Product Change Notification - SYST-01PXUE416

ERRATA - PIC32MZ Embedded Connectivity with Floating Point Unit (EF) Family Silicon Errat

Description of Change: 1) Added Silicon issues: UART

PIC32MZ Embedded Connectivity with Floating Point Unit (EF) Family Silicon Errata and Data Sheet Clarification

FIGURE 1: POSC CRYSTAL CIRCUIT

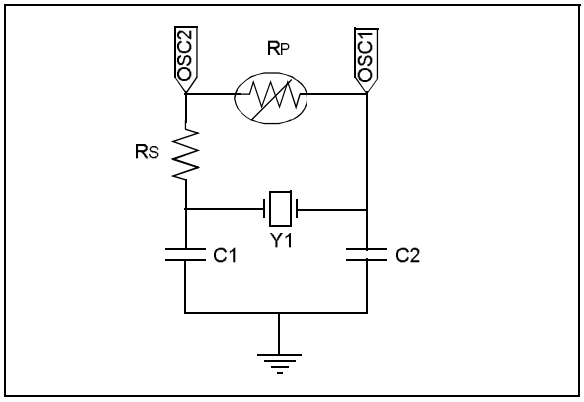
Revision A1 Silicon: A crystal oscillator cannot be used as an input to the Primary Oscillator (POSC) pins OSC1 and OSC2.

Revision A3 Silicon: The POSC has been tested in a normal power-up sequence and supports specific crystal operation.

The Primary Oscillator (POSC) has been characterized to operate at 8 MHz, 12 MHz, and 24 MHz when the circuit in Figure 1 is implemented, and the operating conditions listed in Table 3 are met.

Updated Figure 1 and Table 3 in silicon issue 2. Module: (Oscillator).

Revision A3 Silicon Work around 1

Note 1: Using any other crystal frequency will require special component selection and characterization.

2: A parallel resistor (RP) should not be used to increase the gain of the POSC.
